REVIEW OF IDWR'S MAY 31, 2012 STAFF REPORT

Boise - Mountain Home I84 Corridor

WATER SUPPLY EVALUATION FOR PROPOSED PROJECTS ALONG THE I-84 CORRIDOR¹

November 14, 2012

Figure 2

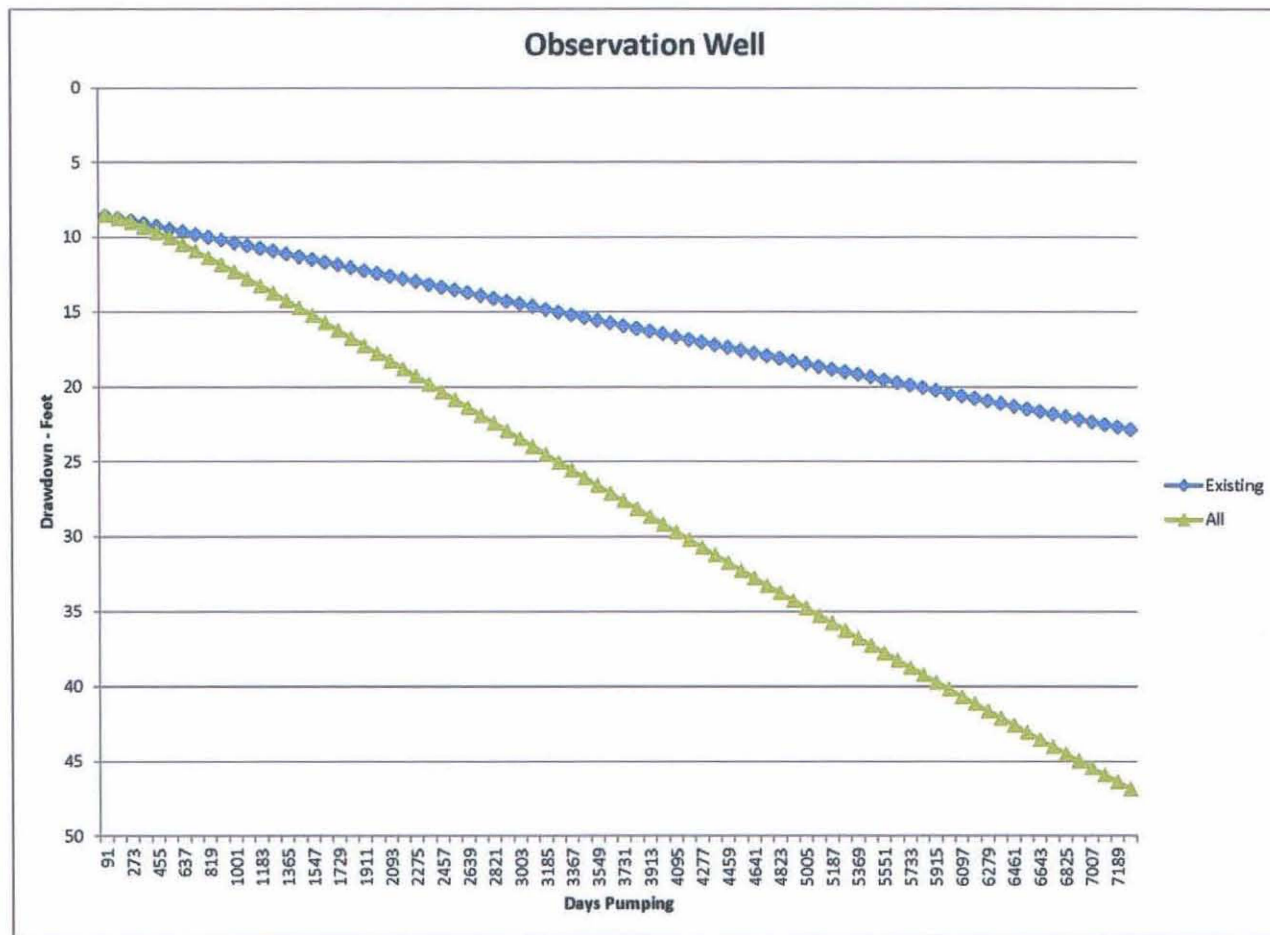
The existing permits, transfers and new water right applications were then added to the analysis and the second 20 year simulation was run a second time. The projected drawdown is shown on Figure 2 below as "All" and shows a drawdown of about 47 feet in the second 20 years, about double the drawdown that is forecast if existing conditions remain unchanged.

Figure 3

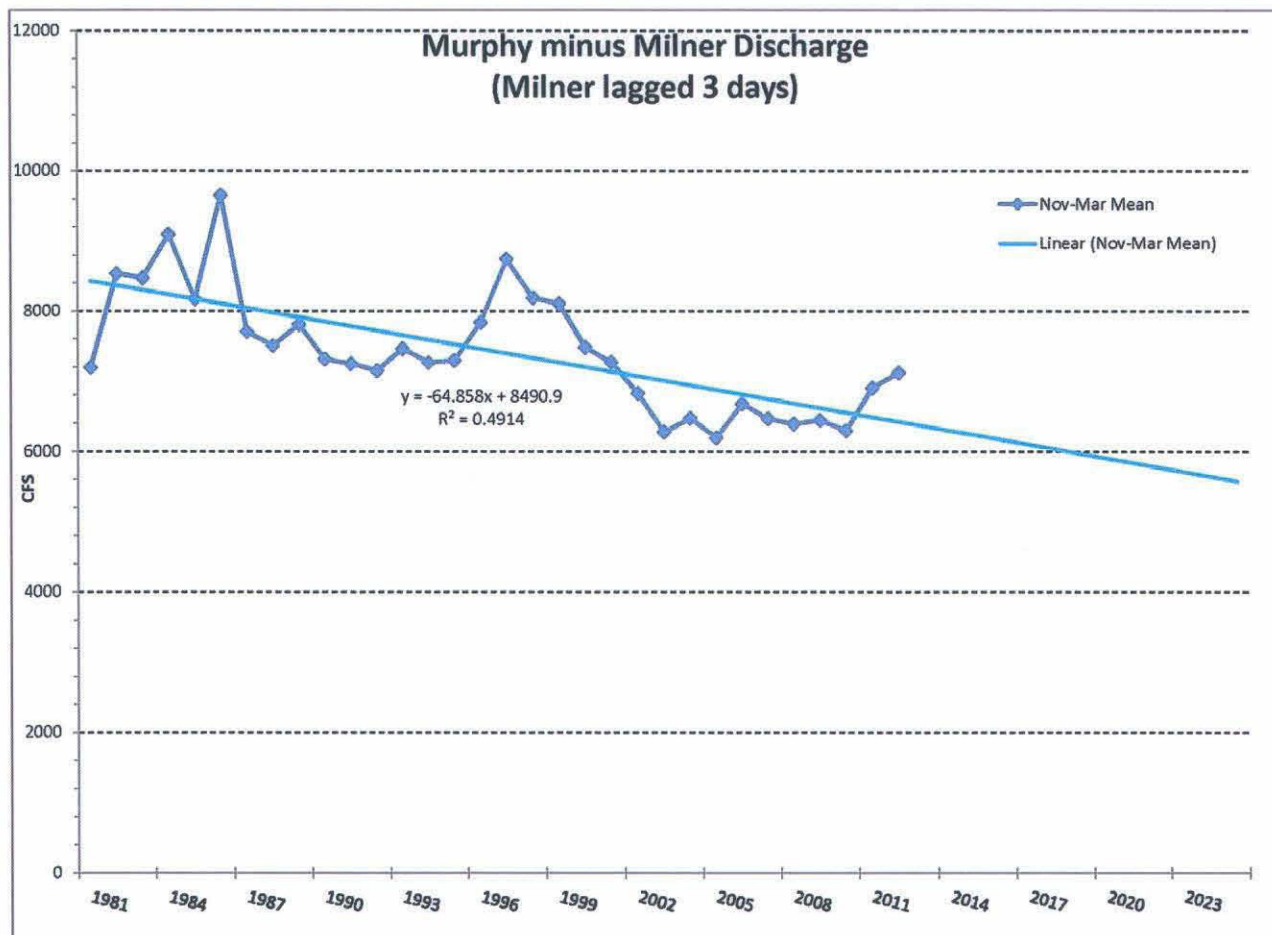
Figures 3 and 4 below were produced using mean daily flows for Murphy and Milner, modified as described above, and averaged for the winter and summer periods respectively. Figure 3 suggests the average mean daily winter discharge at Murphy, as modified above, has declined about 2,000 cfs since 1981 and is continuing to decline at about 65 cfs per year. Projecting this rate of decline forward from 2012 for 13 years suggests the average mean daily flow for the winter of 2025 will be 5,600 cfs, the winter minimum flow established by the Swan Falls Agreement and approved by the Idaho Legislature.

Figure 4

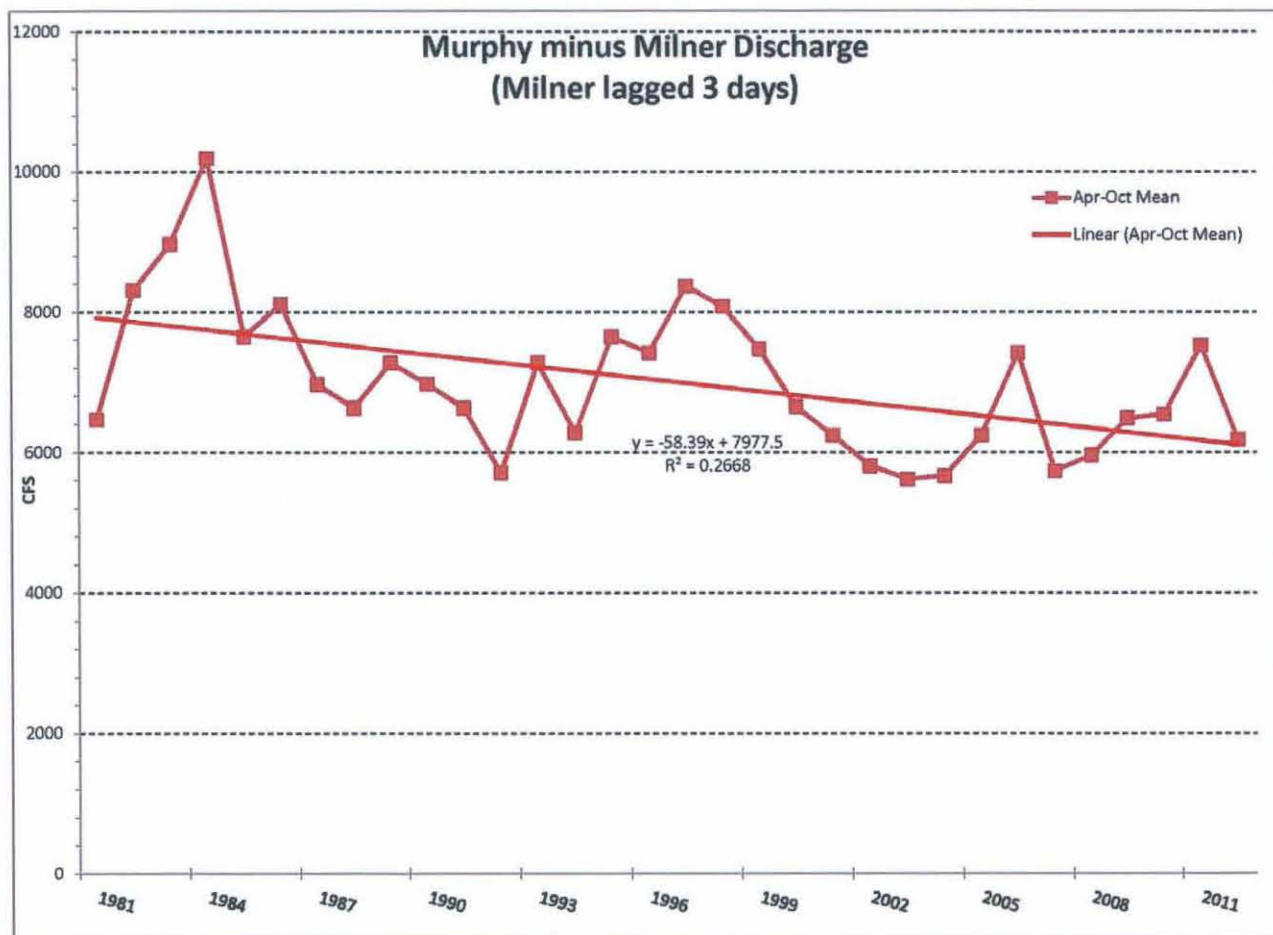
Figure 4 suggests the average mean daily summer discharge at Murphy, as modified above, has declined about 1,850 cfs since 1981 and is continuing to decline at about 58 cfs per year. The average summer flows are still high enough there is no immediate danger the entire average summer flow will decline to 3,900 cfs, the summer minimum flow established by the Swan Falls Agreement and approved by the legislature. Summer flows are, however, quite variable, and time periods shorter than the 7 months from April through October were examined to determine if one period was consistently lower than the entire summer period. To perform that analysis, monthly averages of mean daily summer flows at Murphy, as modified, were calculated for the months April through September with the lowest month being July.
